AMENDMENTS TO THE DRAWINGS

REMARKS

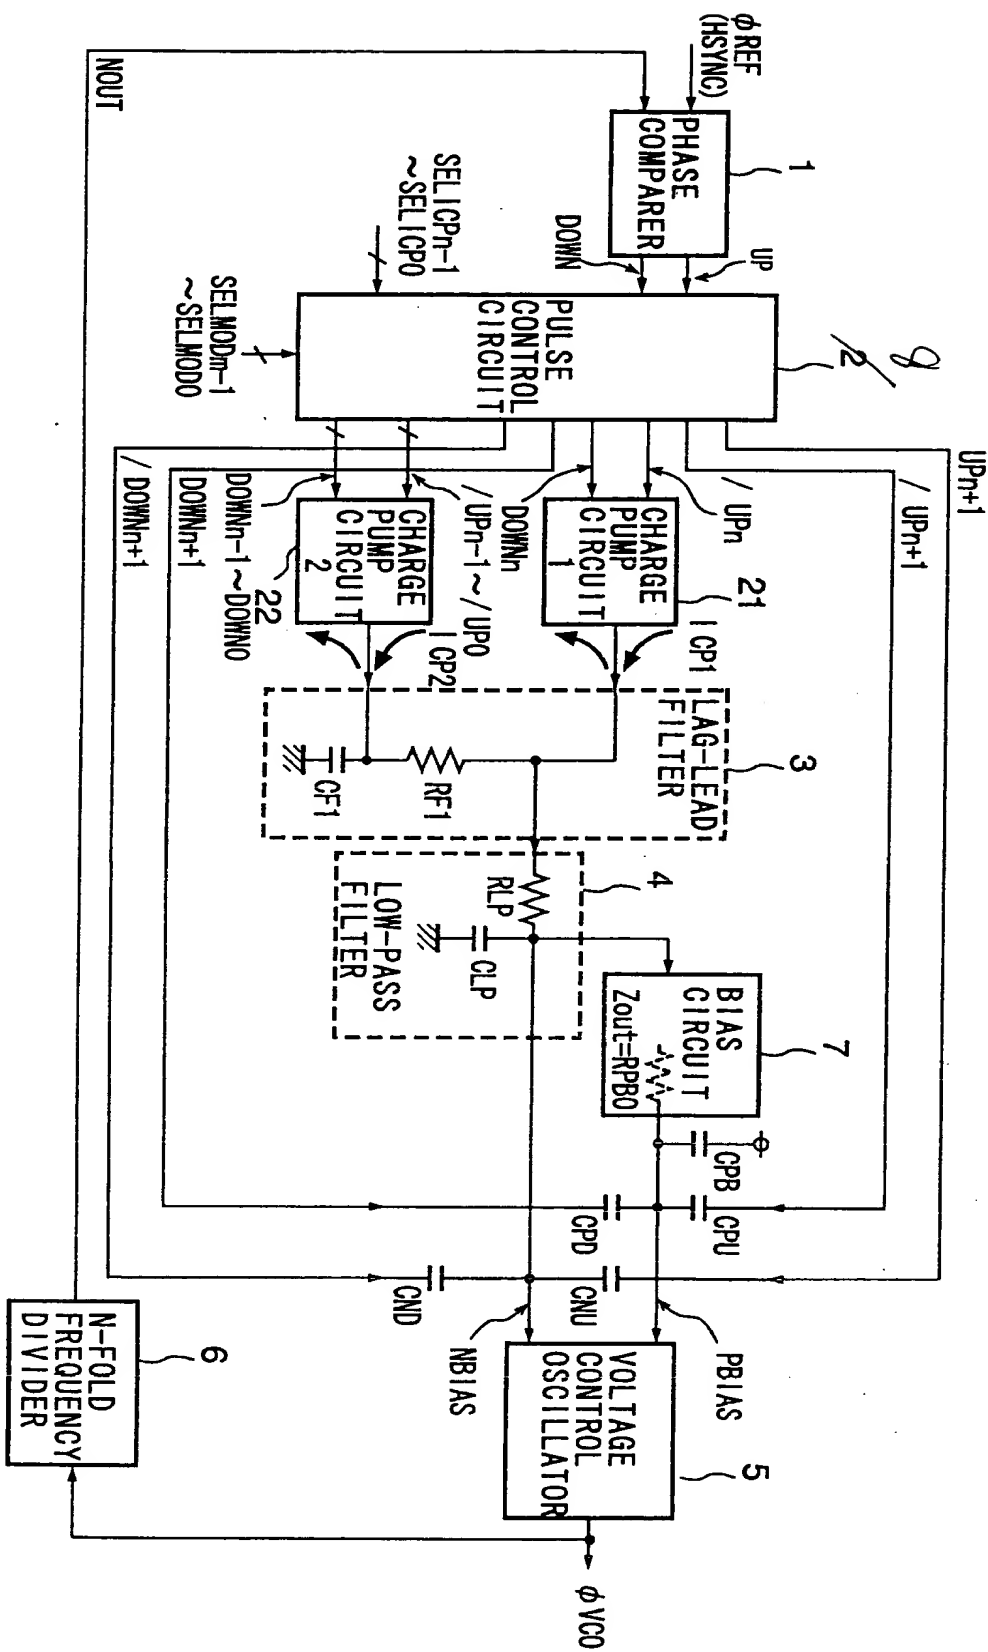
Sheet 1 includes Fig. 8 – Please amend reference numeral -- 2 -- to “8” for the pulse control circuit.

FIG. 11 *Prior Art*

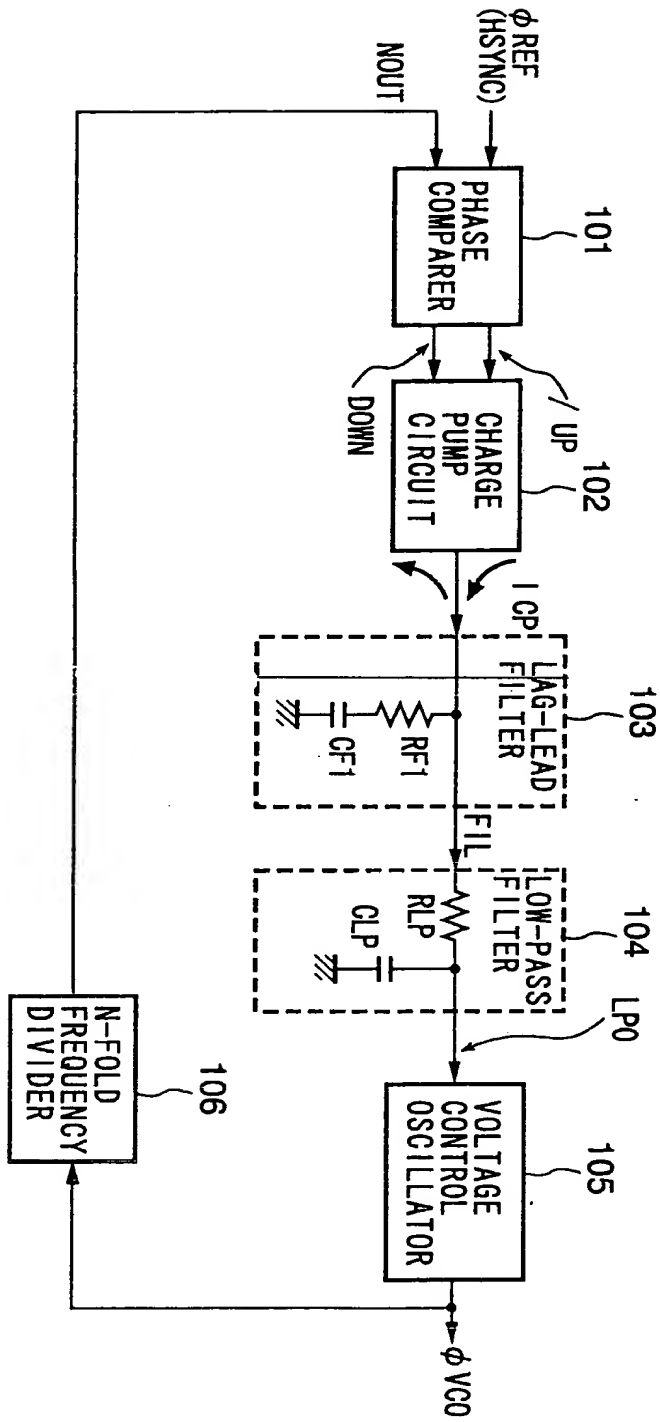
Sheet 2 includes Fig. 11 – Please label this figure as “Prior Art”.

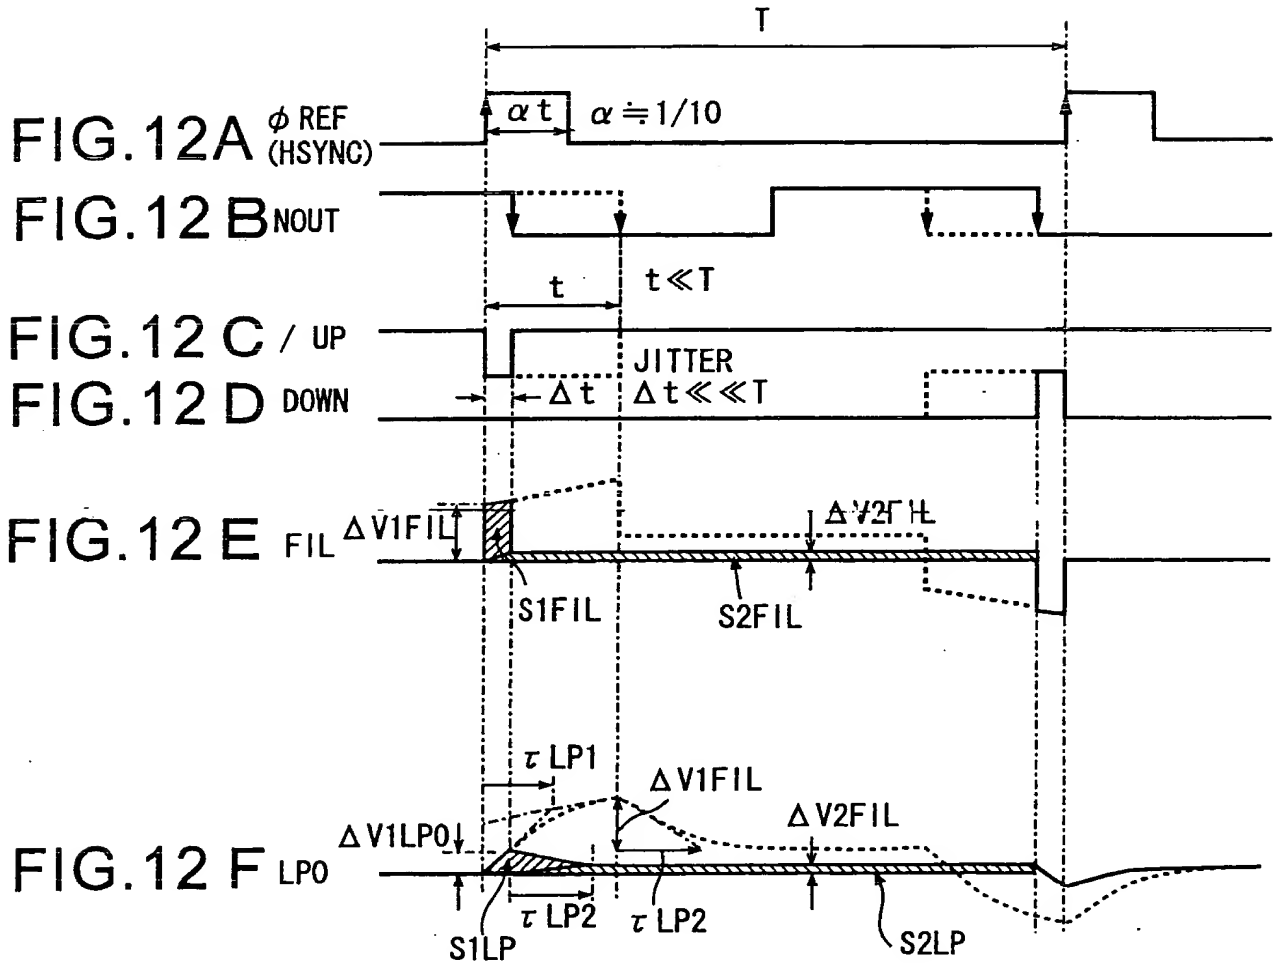
Sheet 3 includes Fig. 12 – Please label this figure as “Prior Art”.

FIG. 13 *Prior Art*

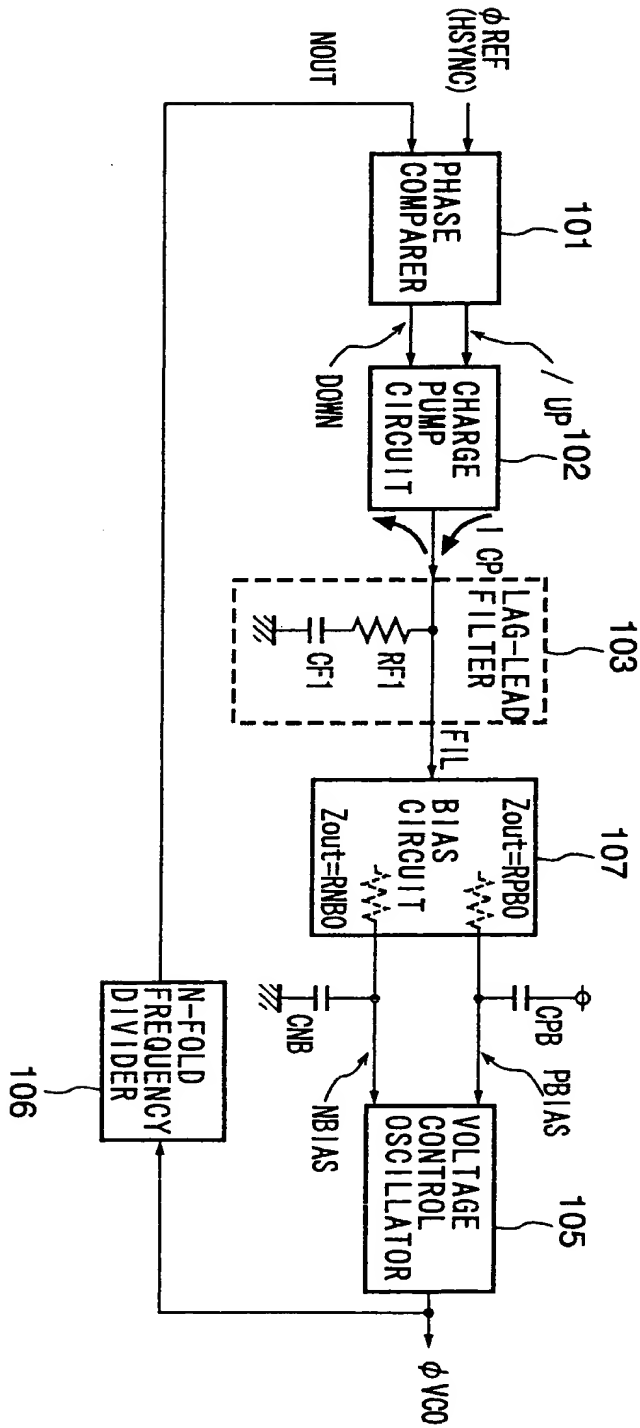
Sheet 4 includes Fig. 13 – Please label this figure as “Prior Art”.

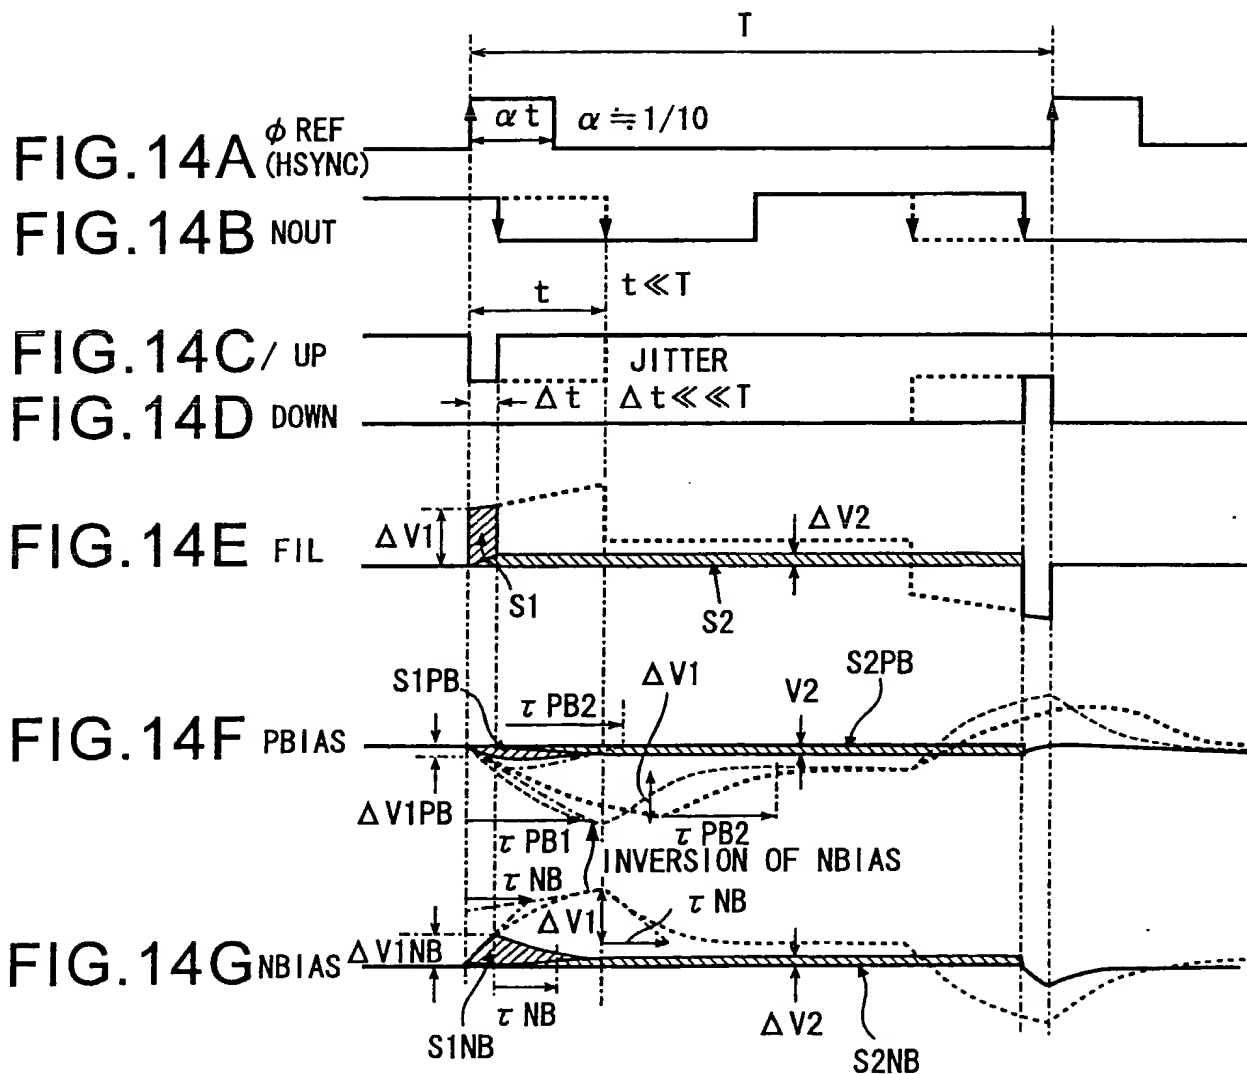
Sheet 5 includes Fig. 14 – Please label this figure as “Prior Art”.

FIG.15 Pr 102 Art 1

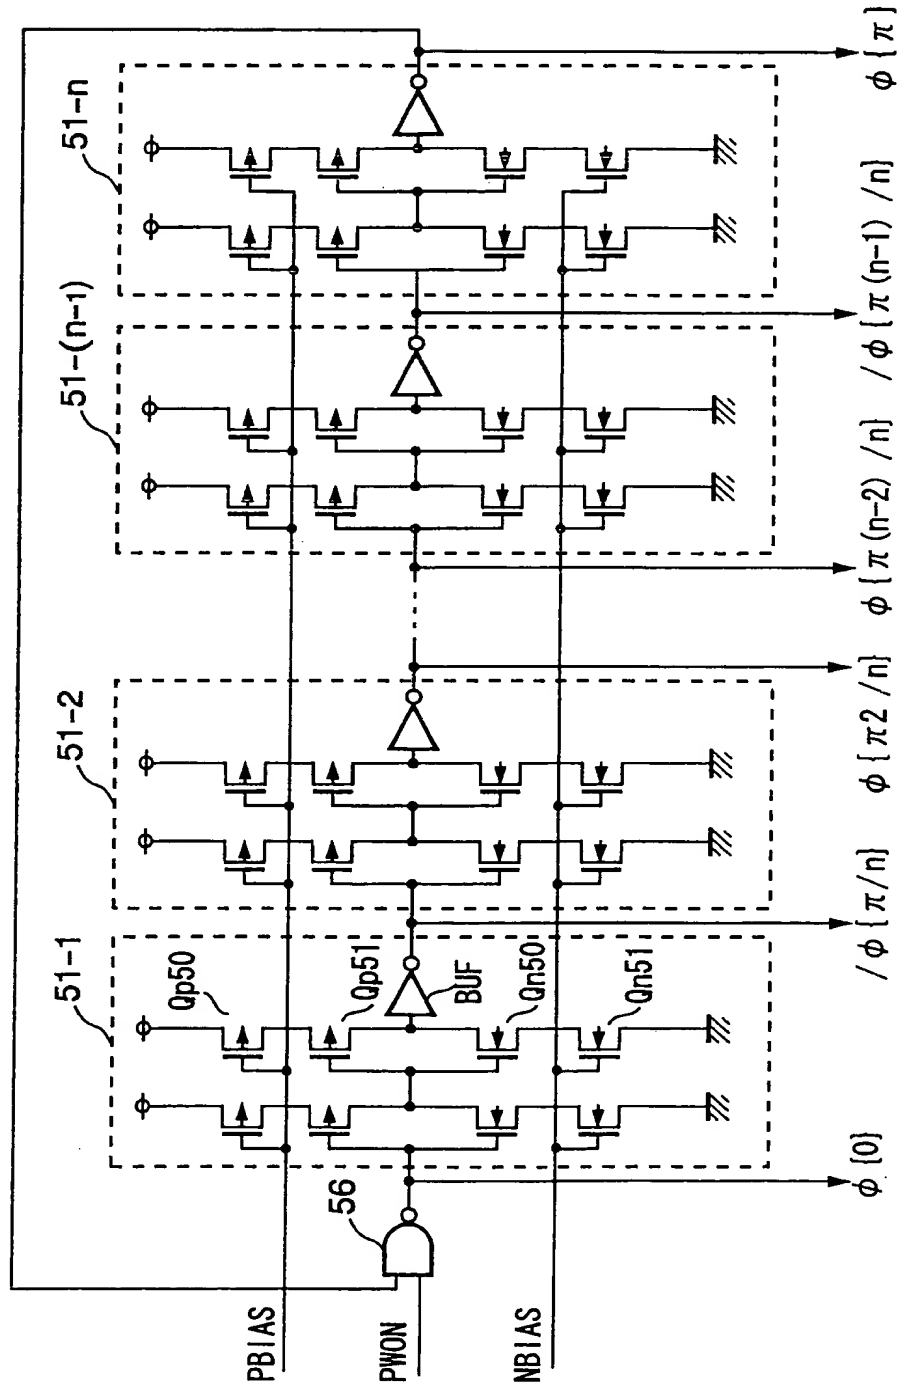
Sheet 6 includes Fig. 15 – Please label this figure as “Prior Art”.
